The Town of Hilton Head Island Regular Design Review Board Meeting

Tuesday, November 23, 2010

DESIGN TEAM/ DRB COMMENT SHEET

PROJECT Barony Beach Club

Sheet Title:
 PLANS

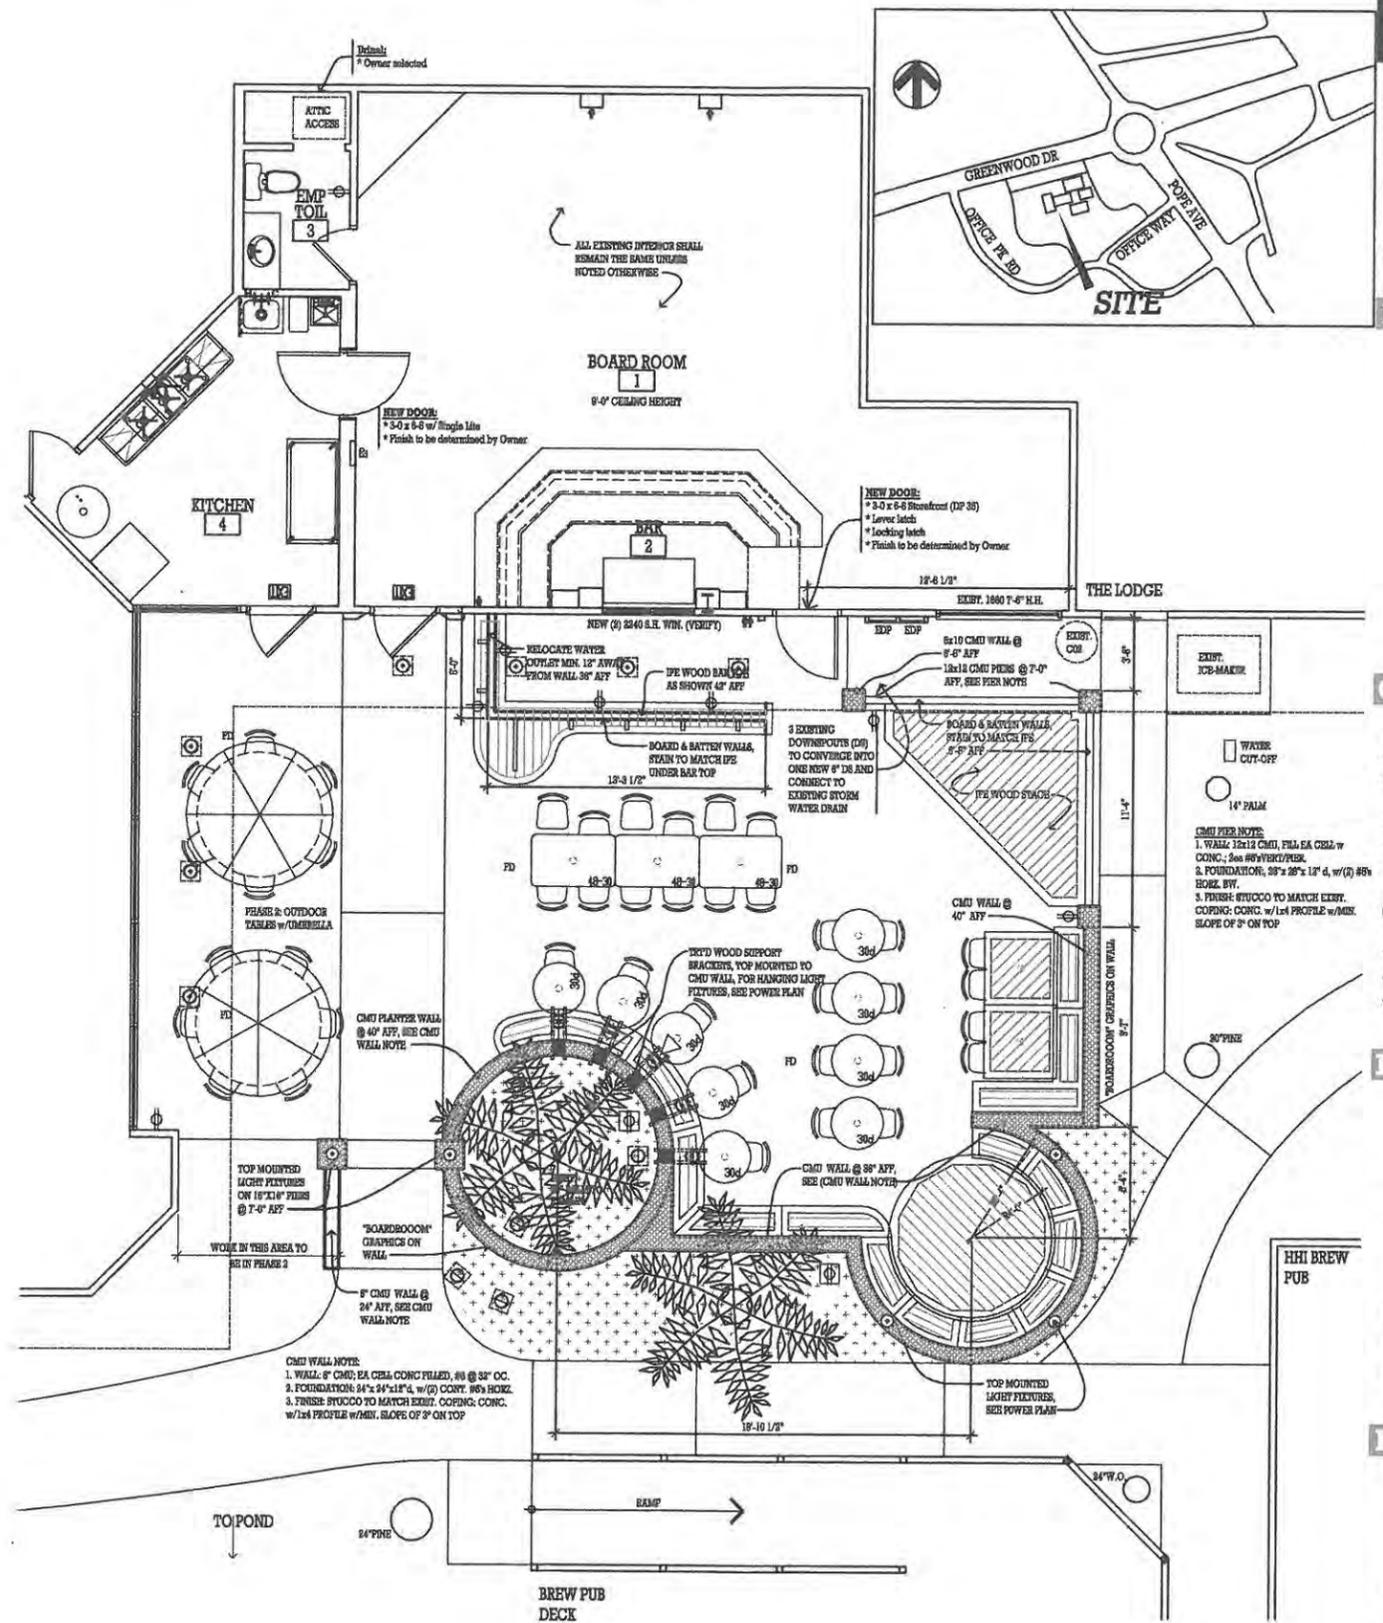
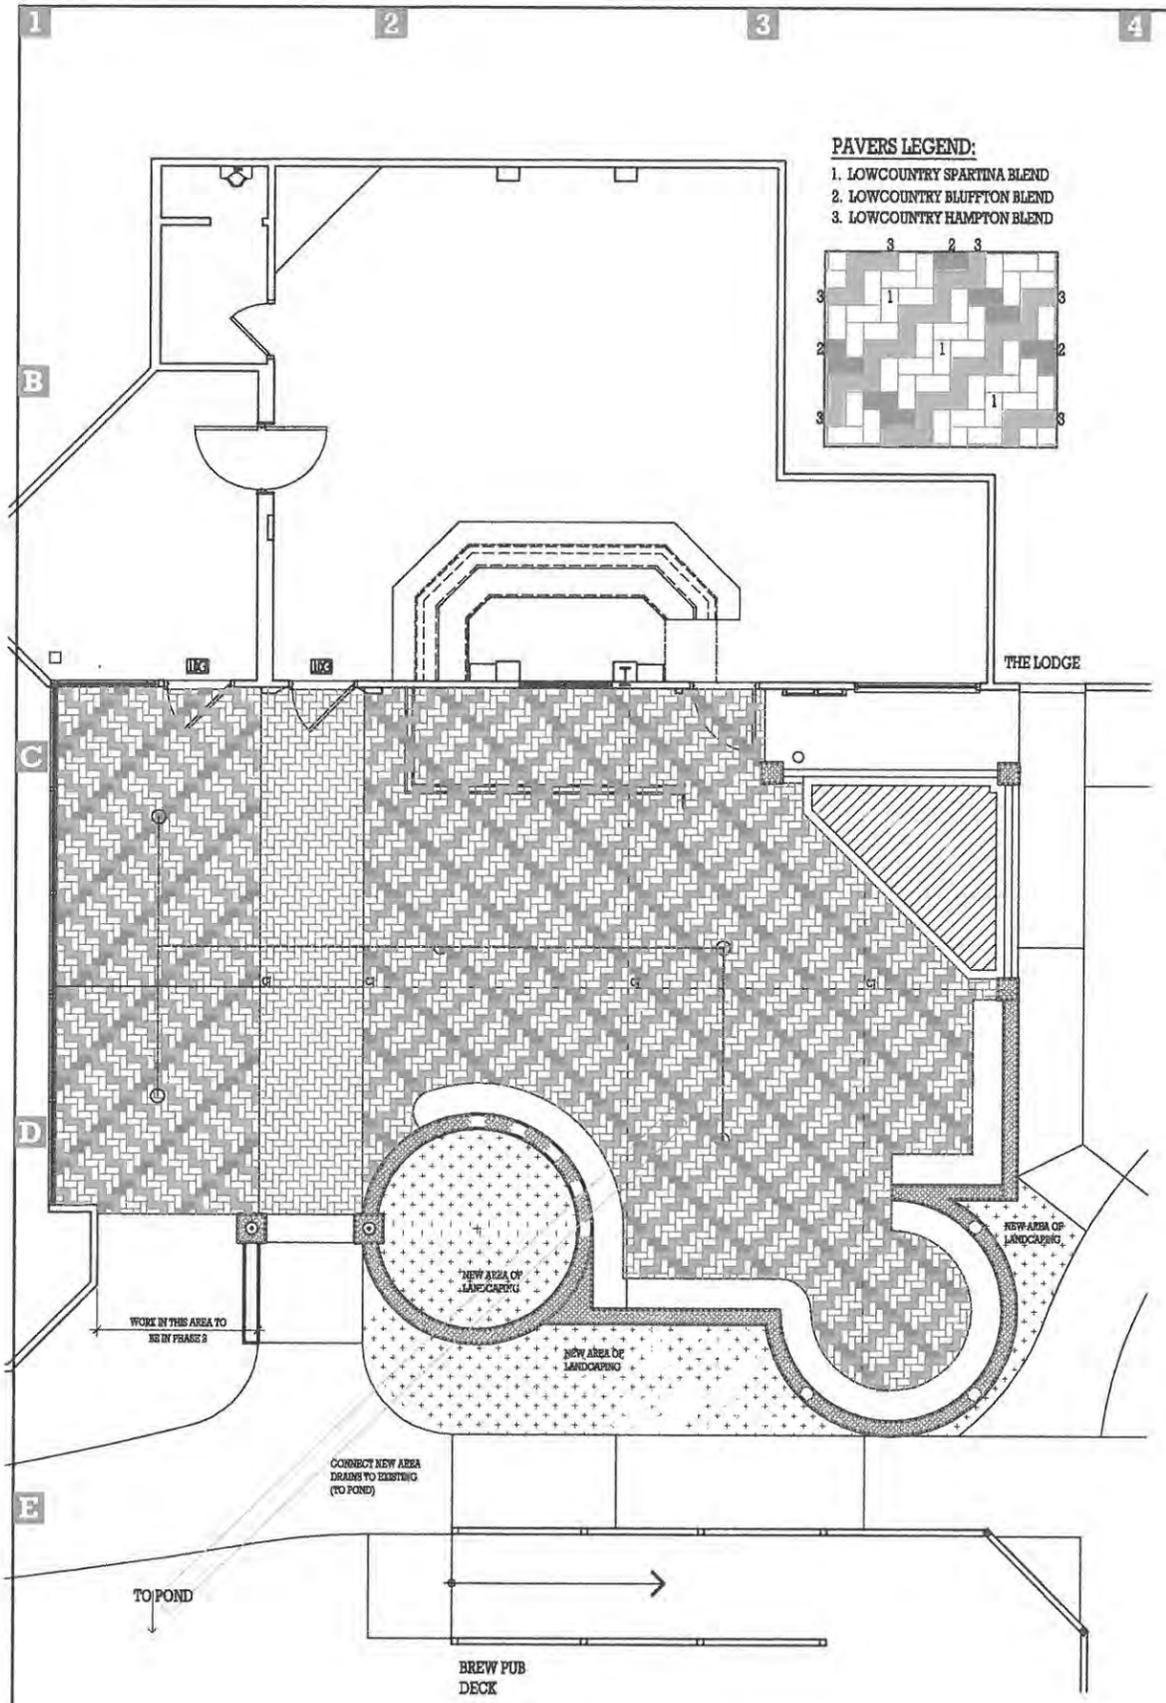
ARCHITECTURAL DESIGN		
The further expansion of outdoor seating at Reilley's Plaza. Material selection and detailing create a humanly scaled space. Per Building and Fire Codes, the added exterior seating will have to be calculated into the existing occupant load to ensure the plumbing fixtures are the proper number for the presumed loading. Any usable space created under the roof overhang will require a sprinkler system.		
DESIGN GUIDE/LMO CRITERIA	COMPLIES YES/NO/N/A	COMMENTS OR CONDITIONS
Structure is designed to be appropriate to the neighborhood	Y	
Promotes pedestrian scale and circulation	Y	
Design is unobtrusive and set into the natural environment	Y	
Utilizes natural materials and colors	Y	
Avoids distinctive vernacular styles	Y	
Design is appropriate for its use	Y	
All facades are have equal design characteristics	NA	
Avoids monotonous planes or unrelieved repetition	NA	
Has a strong roof form with enough variety to provide visual interest	NA

LANDSCAPE DESIGN
A full landscape plan will be required for the areas designated on the plan. A schedule using the ferns, dwarf yaupon holly, etc. existing in the field would integrate the addition of the seating area

DESIGN GUIDE/LMO CRITERIA	COMPLIES YES/NO/NA	COMMENTS OR CONDITIONS
An effort has been made to preserve existing trees and under story plants		Narrative says that outdoor seating area will be pervious, but that it will be set on a “concrete and sand sandwich”. The concrete would then make it impervious.
Supplemental and replacement trees meet LMO requirements for size, species and number		
Wetlands if present are avoided and the required buffers are maintained		
Sand dunes if present are not disturbed
